RFP 6 REVISED: 10/17/08ab  
ADDENDUM 3 REVISED: 8/20/07  
REVISED: 2/19/07  
REVISED: 1/24/07

3RD FLOOR PLUMBING PLAN  
ST. TAMMANY PARISH ADMIN. COMPLEX  
520 OLD SPANISH TRAIL  
SLIDELL, LOUISIANA

RENOVATE OFFICE BUILDING  
**DAMMON ENGINEERING, INC.**  
1095 FLORIDA AVENUE 985-649-5832 SLIDELL, LA. 70458  
DAMMONENGINEERING.COM

P - 3

THIRD FLOOR PLUMBING PLAN  
SCALE: 1/8" = 1'-0"

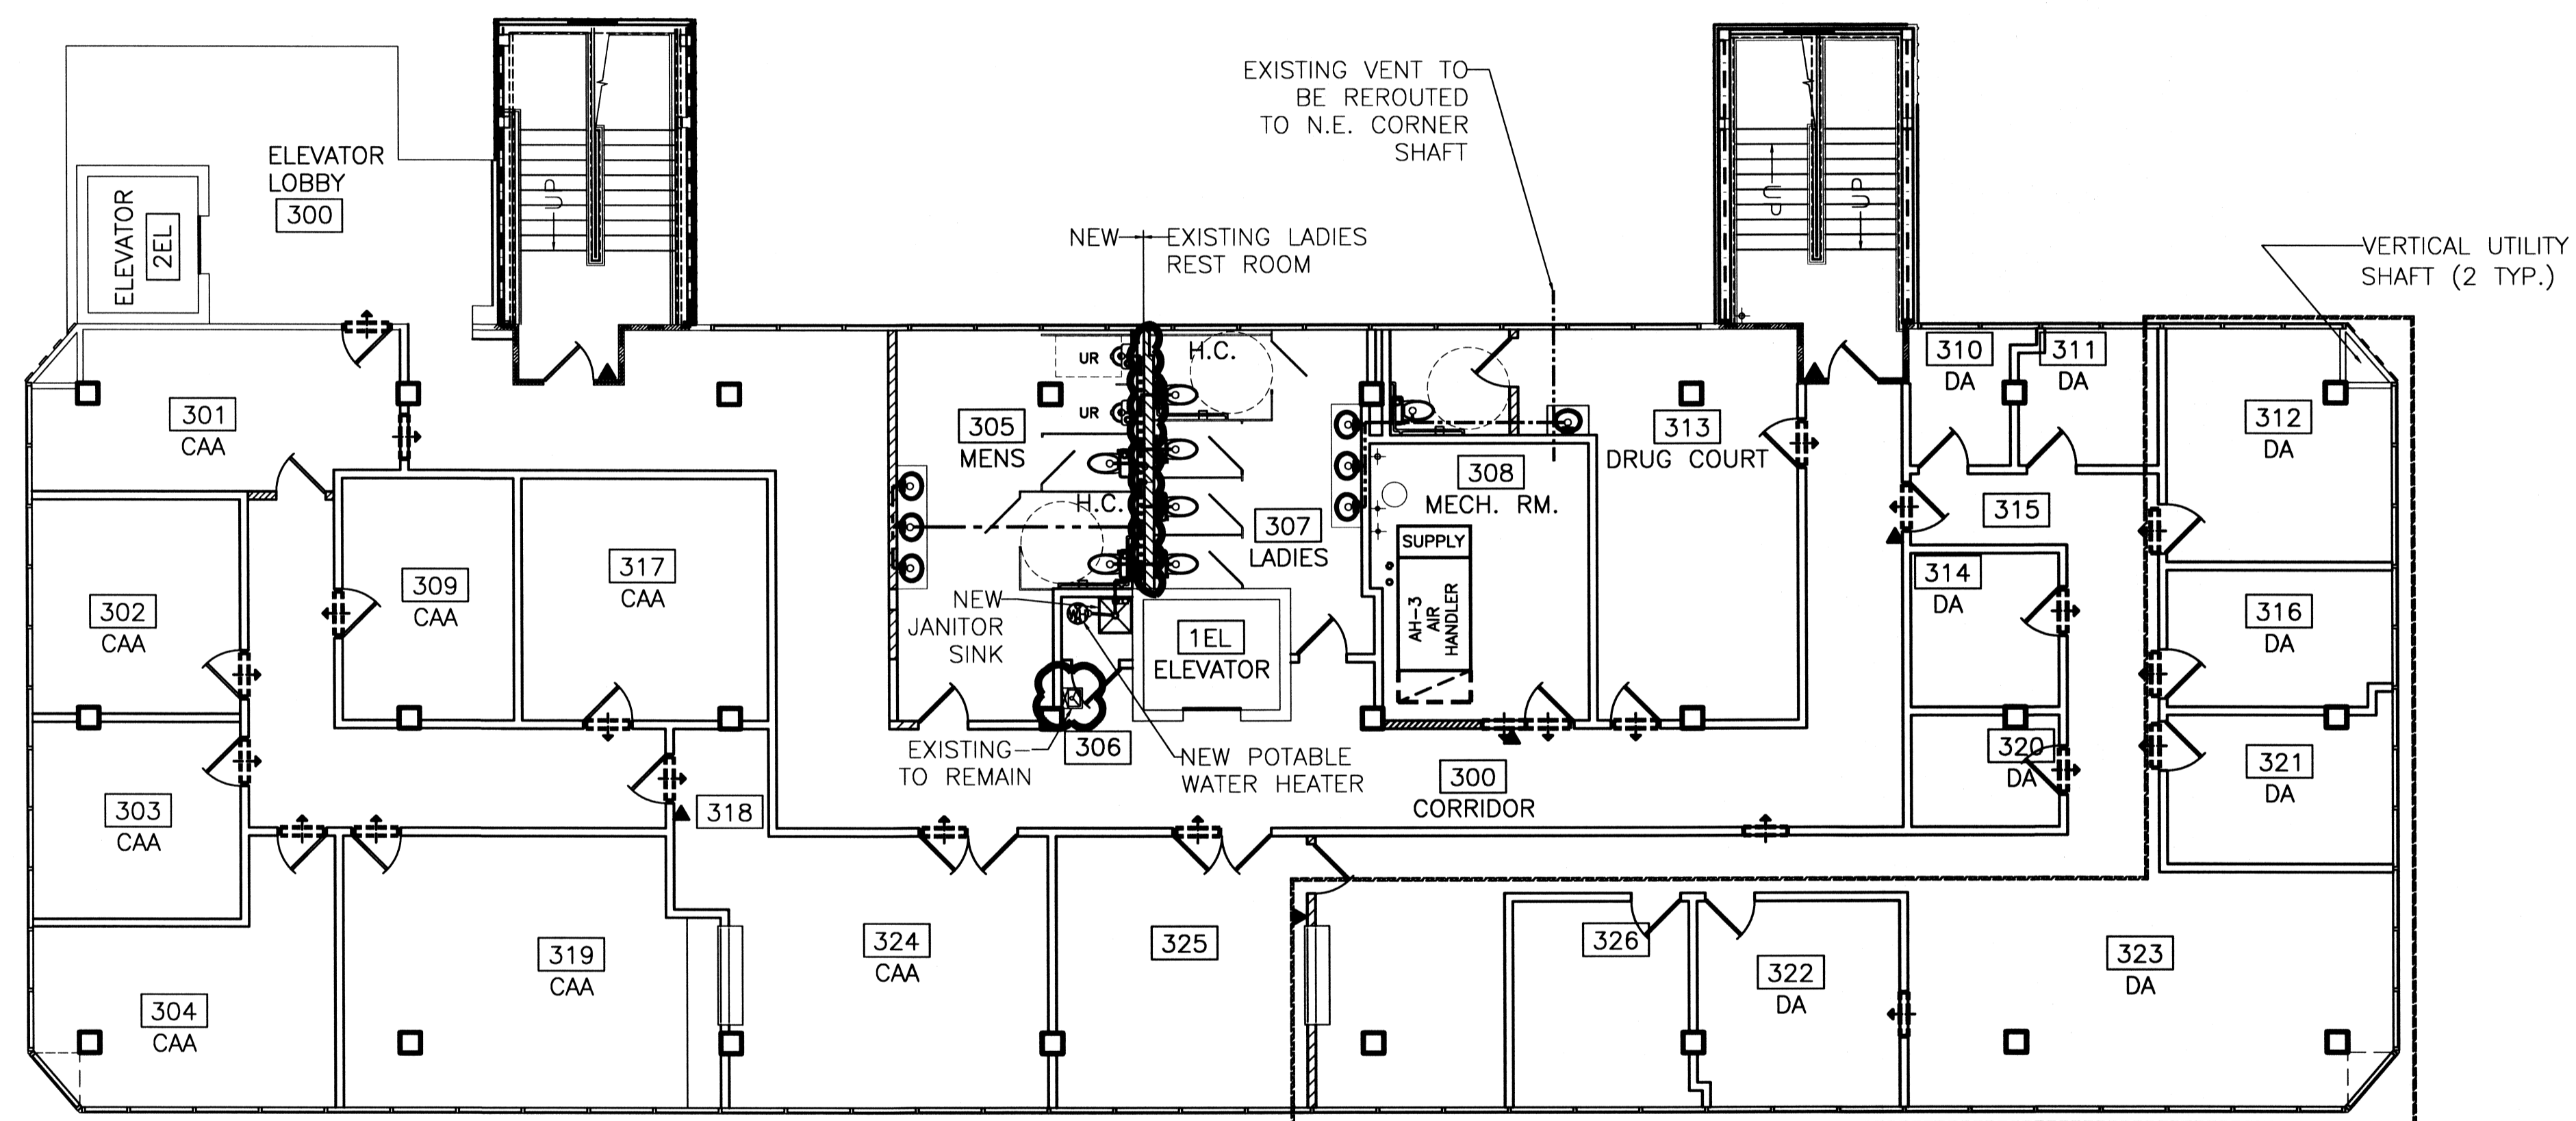
☐ - INDICATES AREAS CHANGED - 10/17/08

☁ = ADDENDUM 3 CHANGE

1. MENS IS A NEW RESTROOM AND WILL REQUIRE EXTENDING SERVICES THRU THE WALL, NEW WALL SUPPORTS FOR WALL HUNG FIXTURES, ETC. DRAIN FROM LAVATORIES MUST BE NEW THRU FLOOR AND EXTENDED TO EXISTING SERVICE.
2. NEW VENT LINES SHALL RUN TO N.E. CORNER VERTICAL OPENING TO ROOF.
3. SEE DRAWING P-1 FOR GENERAL NOTES.
4. MENS ROOM URINALS CAN BE CLEANED AND RE-USED. REPLACE ALL WATER CLOSETS, PIPING AND PIPING FIXTURES.
5. LADIES ROOM WATER CLOSETS CAN BE CLEANED AND REUSED. REPLACE ALL OTHER FIXTURES, PIPING AND PIPING FIXTURES.

6. REPLACE ALL TOILET SEATS AND SANITARY NAPKIN DISPOSAL BINS.
7. INSTALL OWNER PROVIDED SOAP DISPENSERS AND TOILET PAPER & PAPER TOWEL HOLDERS.
8. INTEGRAL LAVATORY/VANITY: CULTURED MARBLE, SIZE AS SHOWN ON DRAWING A-21.
9. URINALS: TOTO UT447 (OR EQUAL) WITH TOTO TMU1NNC 1Gpf FLUSH VALVE (OR EQUAL).
10. WATER CLOSETS: TOTO CT705 (CT705L FOR HANDICAP) WITH TOTO TMTNNC-32 1.6 Gpf FLUSH VALVE, AMERICAN STANDARD 2234 WITH SLOAN 111 ROYAL 1.6 Gpf FLUSHMETER VALVE (OR EQUAL).
11. TOILET SEATS: KOHLER K-4710-T (MENS), K-4752 (LADIES) (OR EQUALS).
12. PARTITIONS: BOBRICK 1080 SERIES PHENOLIC (OR EQUAL).
13. MIRRORS: SHEET MIRROR 3'-0" HIGH X LENGTH OF VANITY, MOUNTED 3'-4" ABOVE FLOOR.
14. SANITARY NAPKIN DISPOSAL: BOBRICK B354 (LADIES PARTITIONS) (OR EQUAL).
